# **Dunmore Sand and Soil Quarry**

## **Traffic Management Plan**

J210315 RP#1

Item no	Comments	Responses
1.	The CHR intersection shown on dwg EMM-C03 appears to have the end of the new right turn lane to the site too close to the existing right turn lane to the waste depot. There is concern there will be vehicle conflict should two trucks be turning simultaneously into each site. Dwg C04 should show the equivalent right turn manoeuvring template into the waste depot.	The updated drawing EMM-C08 (Attachment A) includes two simultaneous swept paths, the right turn movement into the site and the right turn movement into the waste depot.  The swept paths have been redrawn while keeping the vehicle paths within the right turn lane up to a maximum extent before crossing the BB line. The turning point of the swept path is controlled by the trucks turning radii to enter both the facilities.  There is no vehicle conflict between the two simultaneous movements as shown in the swept path.

DRG. #: **EMM - CO3**

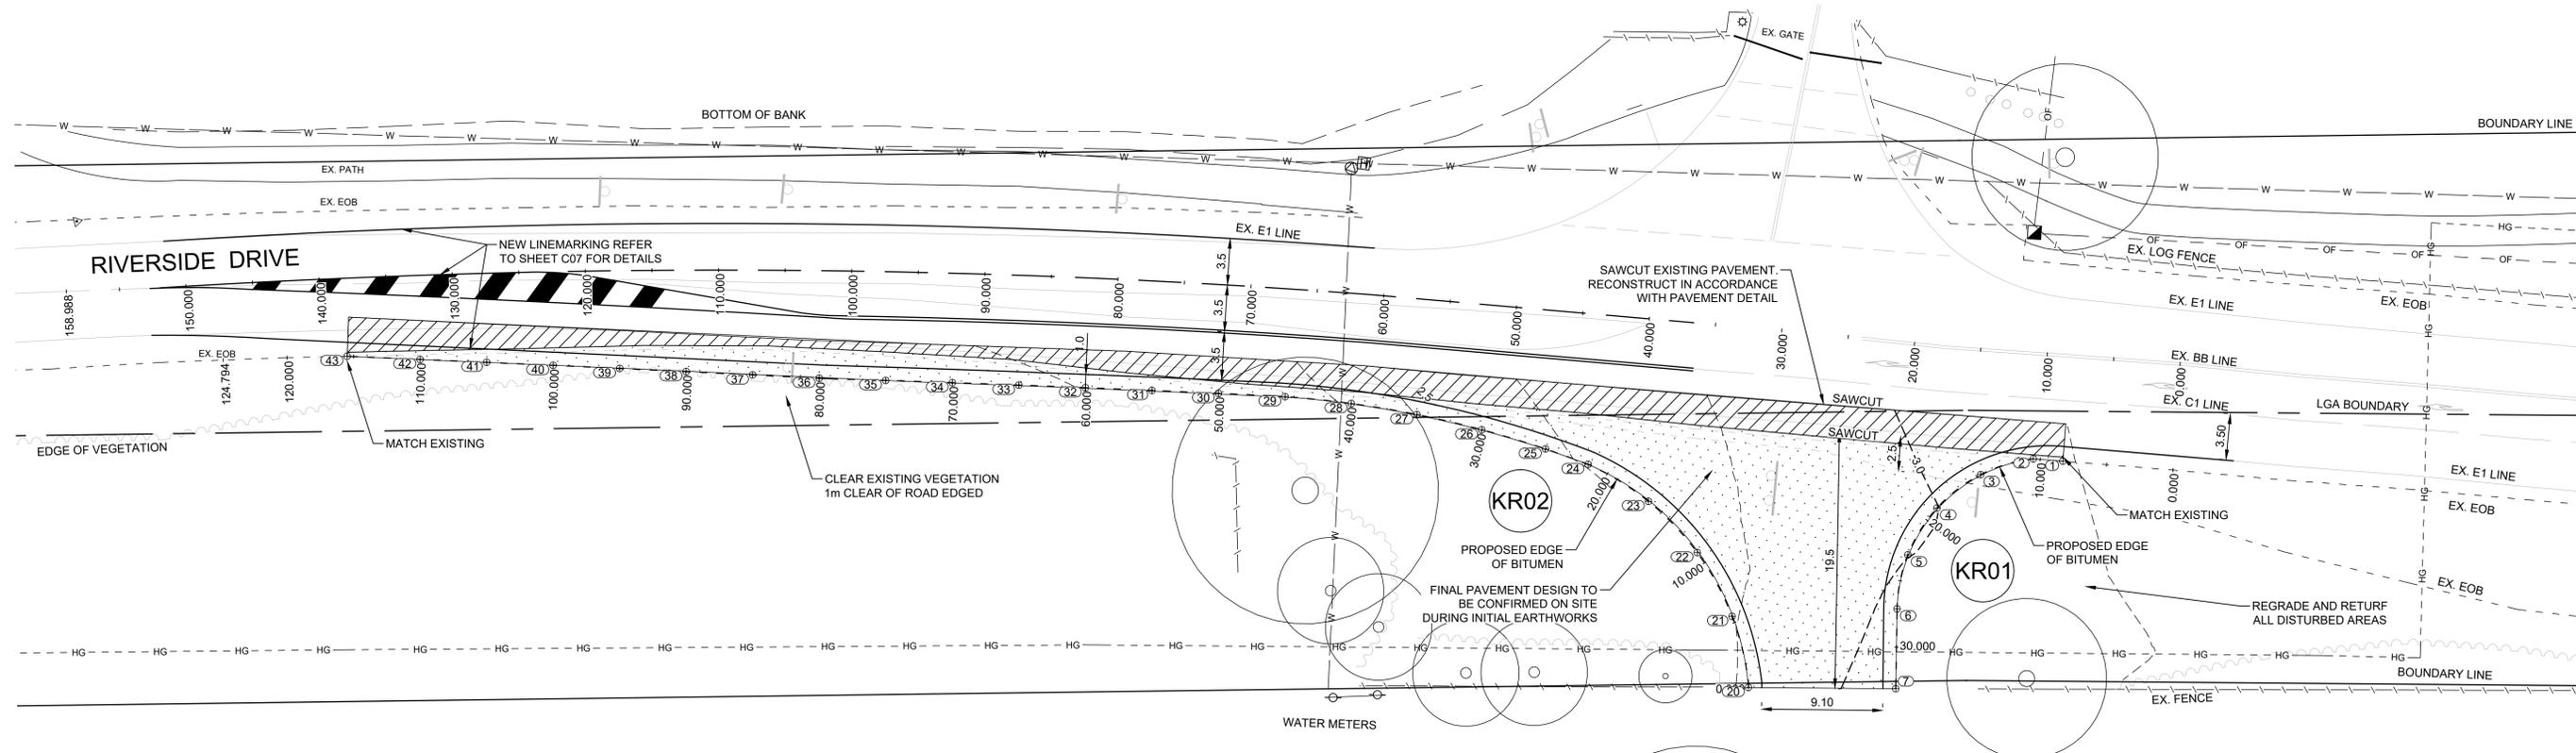
3.	On Dwg C03 there are no dimensions provided that show a truck entering the site will be wholly contained off the Riverside Dr travel lane, if a gate is installed at the existing property fence line.	The updated TMP includes control provisions (Section 5.8) that will ensure no truck approaches the Stage 5A site, without first receiving confirmation at the weighbridge, after being weighed that the gate is open to allow trucks entering the site to enter the site without interruption. Thereby there is no need for trucks to be waiting in the verge of riverside drive, as trucks will wholly enter the site.

there will be vehicle conflict should two trucks be turning simultaneously into each site. Dwg C04 should show the equivalent right turn manoeuvring template into the waste depot.

DRAWING TITLE:  
**CONSTRUCTION PLAN**

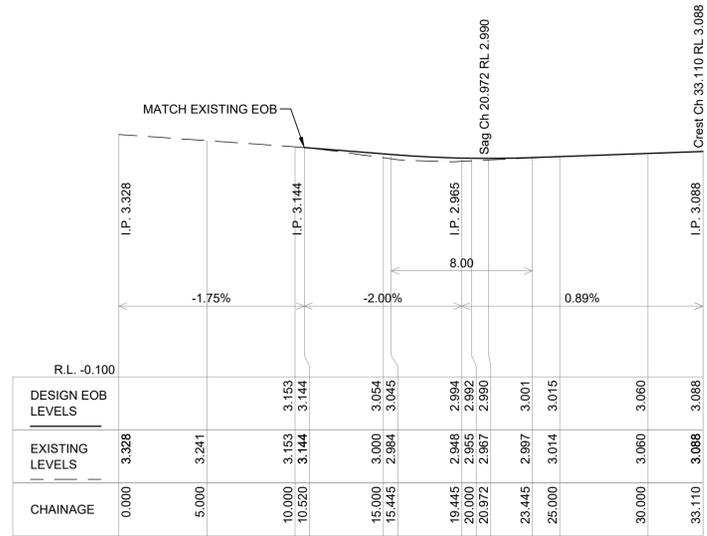
2.	Dwg C04 shows the truck turning template entering the site, tracking over a substantial portion of the proposed BB line shown on Dwg C03. If there are any vehicles exiting the site & waiting to turn right onto Riverside Drive, they will be impacted by this manoeuvre.	The updated drawing EMM-C07 (Attachment A) shows the previous BB line has been replaced by S1 line. The new S1 line has been offset from the centre and drawn inclined at an angle. Additionally, the TB line has been set back by 2.5 metres. The above changes will reduce the impact the right turning truck will have on the exiting vehicles from the site.

2. Dwg C04 shows the truck turning template entering the site, tracking over a substantial portion of the proposed BB line shown on Dwg C03. If there are any vehicles exiting the site & waiting to turn right onto Riverside Drive, they will be impacted by this manoeuvre.
3. On Dwg C03 there are no dimensions provided that show a truck entering the site will be wholly contained off the Riverside Dr travel lane, if a gate is installed at the existing property fenceline.
